State of California
Department of Water Resources
Sustainable Groundwater Management Program
Alternative Assessment Staff Report

Groundwater Basin Name: Corralitos – Pajaro Valley (Basin No. 3-002.01)
Submitting Agency: Pajaro Valley Water Management Agency
Recommendation: Approve
Date Issued: July 17, 2019

Figure 1. Pajaro Valley Subbasin, PVMA jurisdiction, and PVHM model grid

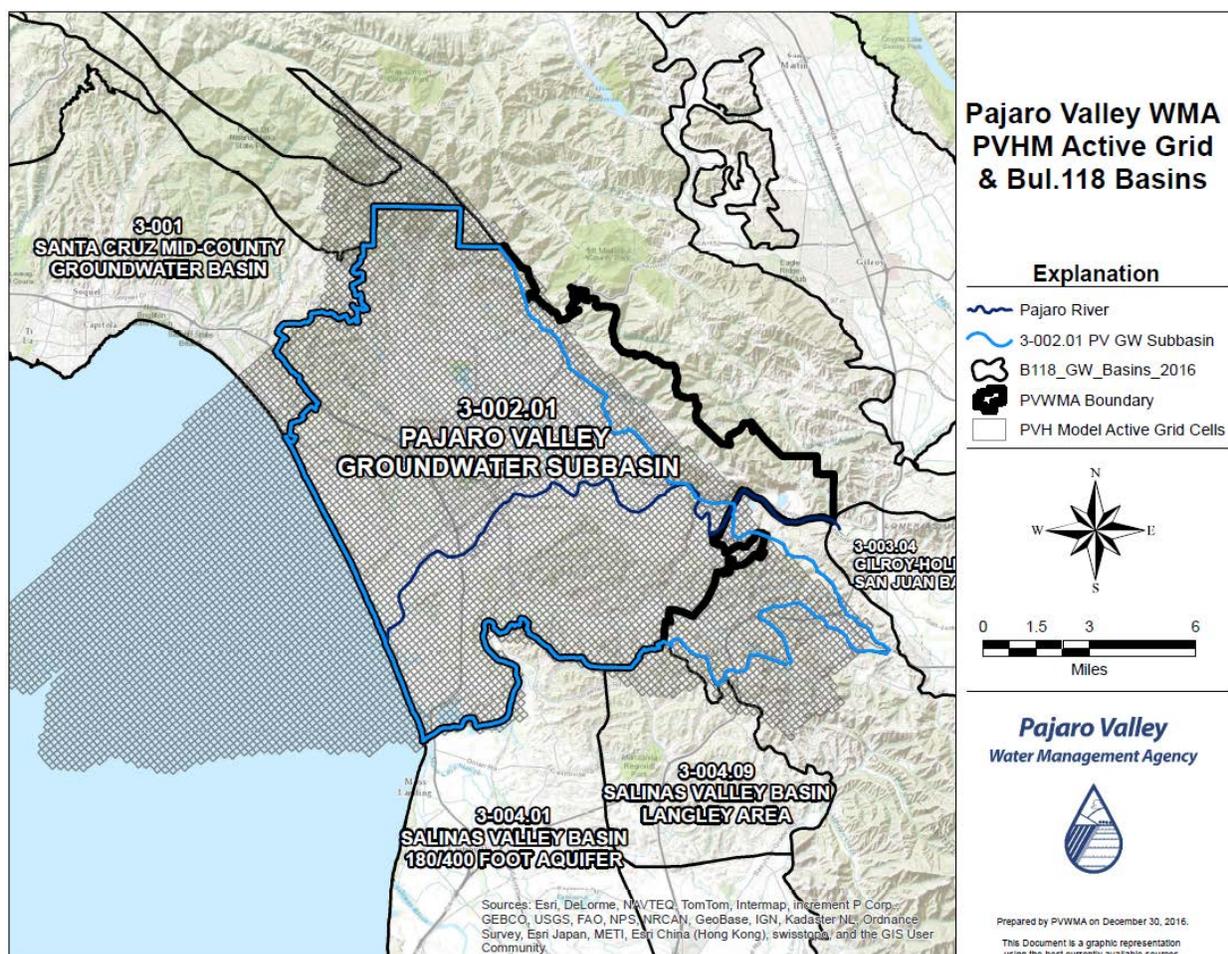
Although Department staff have determined that the Pajaro Subbasin Alternative satisfies the objectives of SGMA (see Assessment, below), the Pajaro Valley Subbasin is not yet sustainably managed. As a result, the Alternative cannot be said to effectively cover the entire Subbasin based on the current avoidance of undesirable results. Instead, staff considered whether the geology and hydrology of the non-jurisdictional area is adequately understood and whether groundwater usage in that area would or would not adversely affect the jurisdictional portion of the Subbasin, and *vice versa*. Staff also considered whether the non-jurisdictional area is or is not experiencing undesirable results or that implementation of the Alternative would result in the avoidance of undesirable results in the non-jurisdictional area.

of the Subbasin, as shown in the map above.³⁵ The area covered by the model, denoted by the hatched pattern on the map, includes virtually the entire area outside the Agency boundaries to the south. Modeling results presented in the PVHM Report, which simulated groundwater levels from 1987 to 2009, show that groundwater levels in the non-jurisdictional portion of the Subbasin did not exhibit declining groundwater levels.³⁶ This was in contrast to the overdraft conditions experienced in the main (jurisdictional) part of the Subbasin, which conditions motivated development of the Basin Management Plan.

Staff recommend that the Agency define how it will assess, on an ongoing basis, the non-jurisdictional portion of the Subbasin and demonstrate that activities in that area are not adversely impacting successful implementation of the Plan within the Agency's jurisdictional area, or adversely affected by implementation of the Plan or by groundwater use in the area not subject to that Plan. That assessment may include, but is not limited to, additional monitoring in the non-jurisdictional areas and agreements with other entities.
